Eight Discipline Report (8D Report)

To: ODM	8D report No.: 20140227
From: : Chicony Power Technology	RMA claim No.: N/A
CC :	Chicony Power P/N: W015R004L-PG01
	Customer P/N: IPV5K6K
Submit date:	Product description: 15W adapter
Receive date: 20140220	Defect D/C or Lot No.:
Subject : No power*1pcs (surge failure, Q1, R1, R1A, ZD5, R16 damaged)

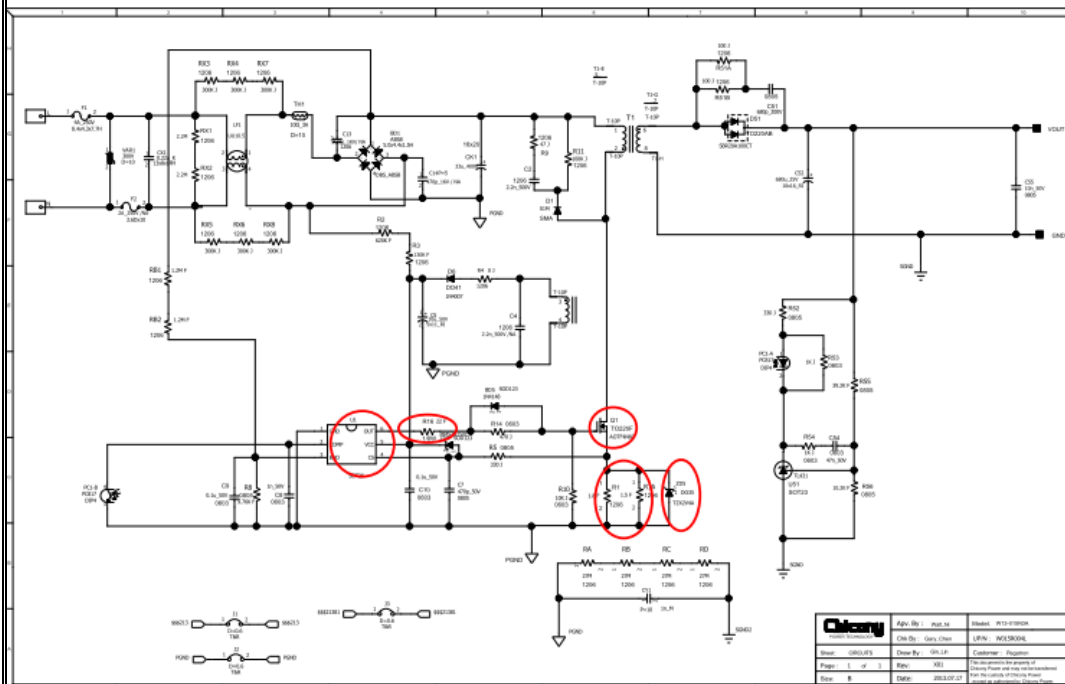
At component side, there is no burning mark or loose parts.

At solder side, there is no burning mark or loose parts.

After further checking, the damaged components are: Q1, R1, R1A, ZD5, R16,

This failure looks like a noise influence → MOSFET blow → R-sense burnt open and PWM damaged.

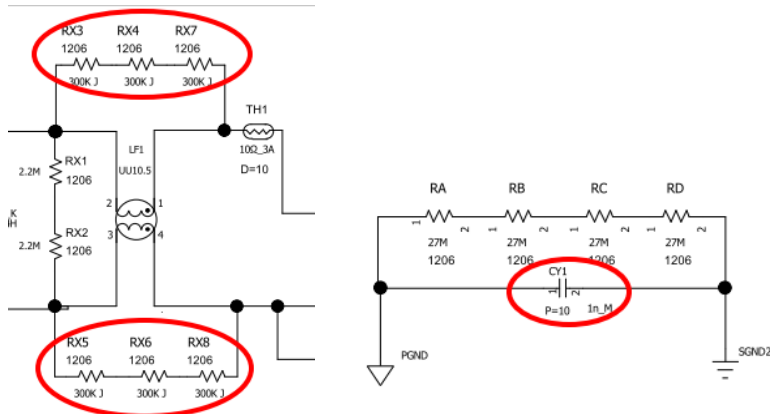
- As this failure is common mode, noise has chance to inject into circuit due to LC resonance caused by choke and Y-cap. To help improving surge capability, we can add more damping to the components to enhance the noise immunity.
- We are trying to enhance surge capability by changing RX3~RX8 and CY1 value. If the solution is OK, we will double check EMI performance.

- We evaluated the solution by test to fail method, applying 4KV→5KV→6KV as step to the units for bi-wave common mode, this test cycles will be much more than standard test condition. We finished 5pcs surge test for common mode, one unit had no output after 6KV and four units still had output after 6KV. Components we changed for evaluation as following.

original	solution
RX3~RX8	330K	255K
CY1	1000p	680p

- Then we prepared 5pcs new samples with solution and did surge test with fully test mode. They passed +10% surge test (4.4KV) with standard test process including common and differential mode. We will continue to do common mode test to fail for these samples.
- The result looks comfortable, common mode pass 5KV and margin is 1KV.
- As requested, we will provide 30pcs new samples with surge solution for customer evaluation.
